Product Change Notification / NTDO-14NLIX570

CCB 4911 Final Notice: Qualification of additional 68x94 mils lead frame paddle size for selected SMSC EMC10xx, EMC14xx and EMC181xT device families available in 10L MSOP (3x3 mm) package assembled at NSEB assembly site.

CCB 4911
Pre and Post Change Summary
PCN #: NTDO-14NLIX570

Pre Change

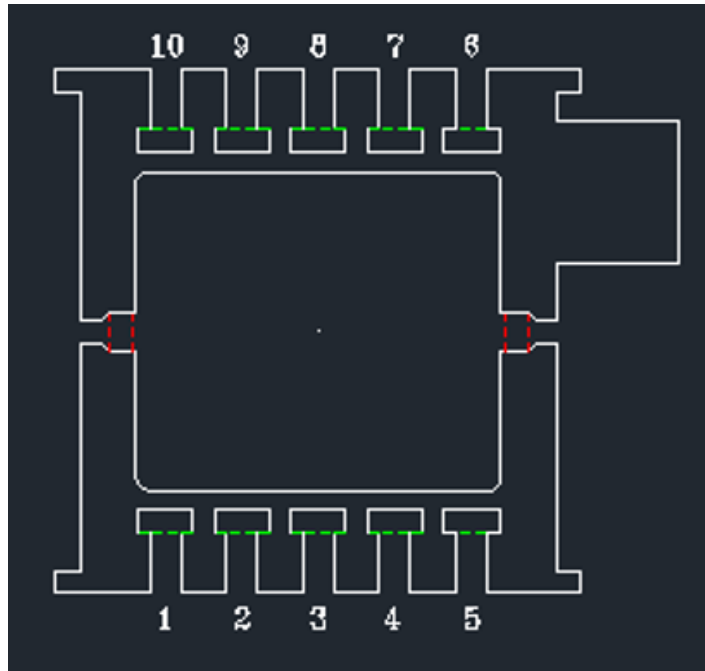
Paddle Size	82x94 mil
Lead-lock	No

Post Change

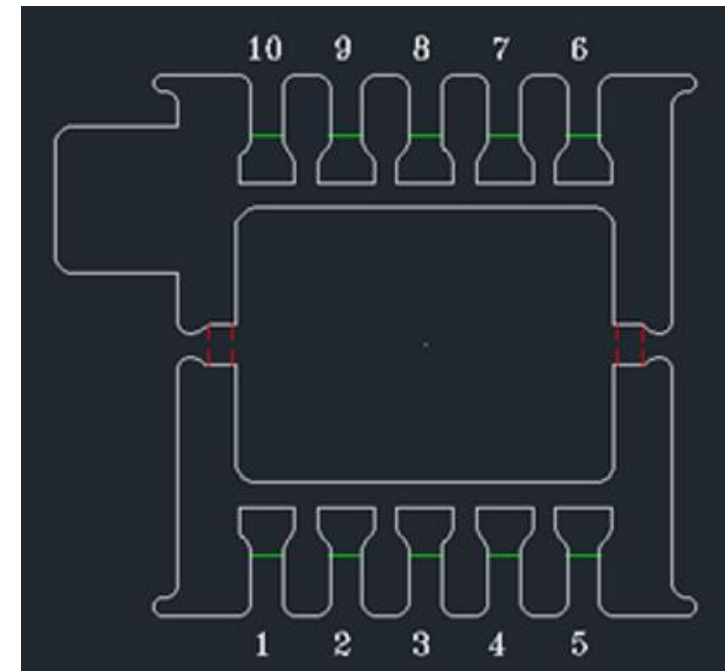
Paddle Size	68x94 mil
Lead-lock	Yes
